ERA AVIATION, INC.	STEP ACTUATOR COMPONENTS	SIZE	DRAW. NO.	REV.
			SH1 2 OF 3	
		C	41232-200-002	A

ENGINEERING ORDER

E.O. No.
B-1SHT.
1 OF 1BY
D. NELSON

STEP ACTUATOR
COMPONENTSDWG. AFFECTED
41232-200-002SHEET AFFECTED
SHT 1 & 3

-001 TUBE

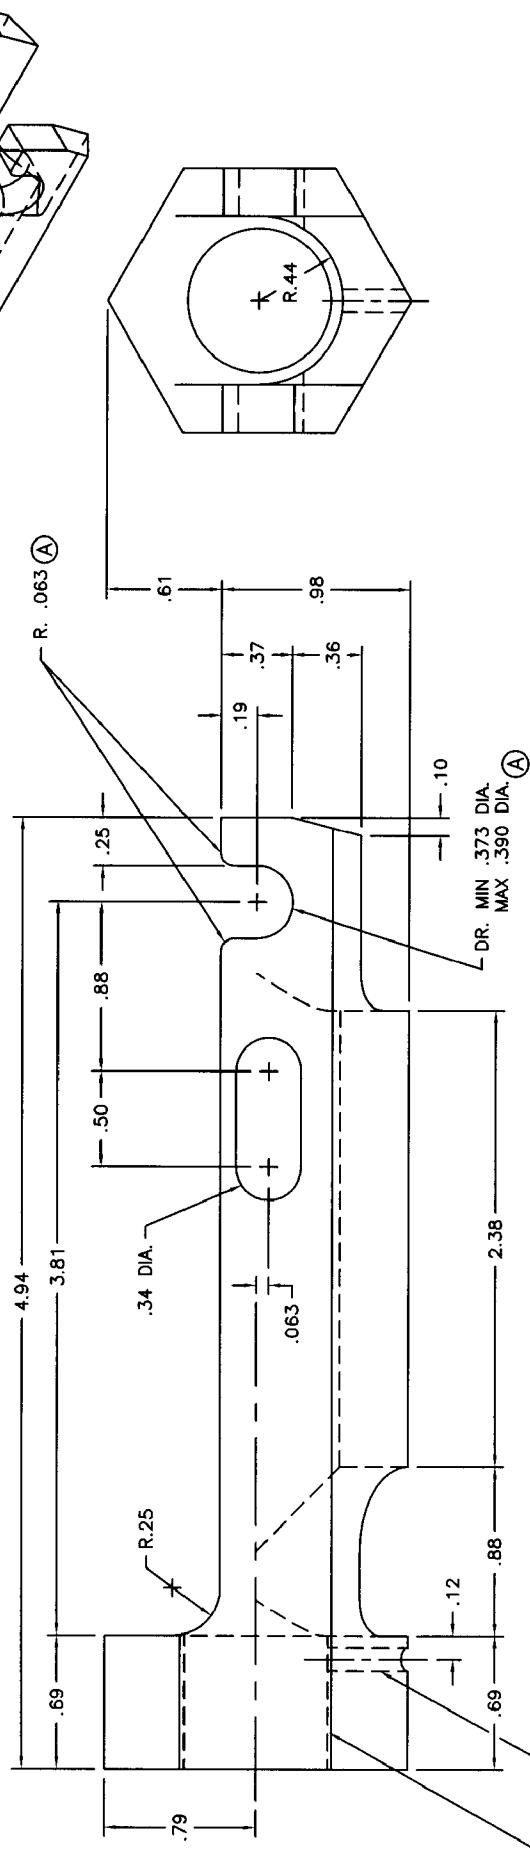
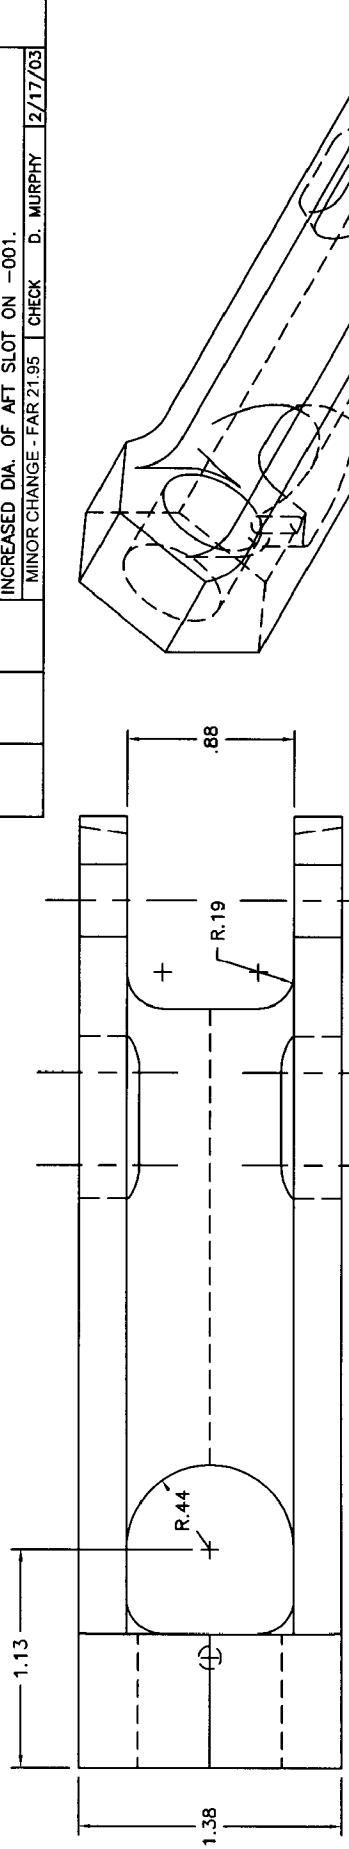
ADDED SMOOTH EDGES TO -001 & -003; REDUCED LENGTH OF -.003 BY .125"; ADDED DRAIN HOLE TO -001;
INCREASED DIA. OF AFT SLOT ON -001.
MINOR CHANGE - FAR 21.95 CHECK D. MURPHY 2/17/03

ISMS21209F4-10
INSERT-005 PIVOT ARMWAS

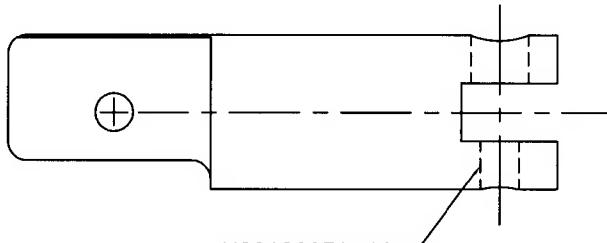
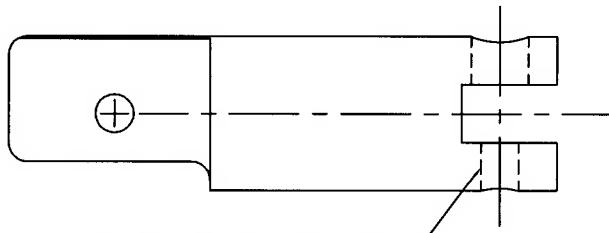
REASON FOR CHANGE: CHANGED DASH NO. OF INSERT ON L/M; CHANGED INSERT CALLOUT ON -005 PIVOT ARM.

IS

1	MS21209F4-10	INSERT
---	--------------	--------

WAS

1	MS21209F4-15	INSERT
---	--------------	--------
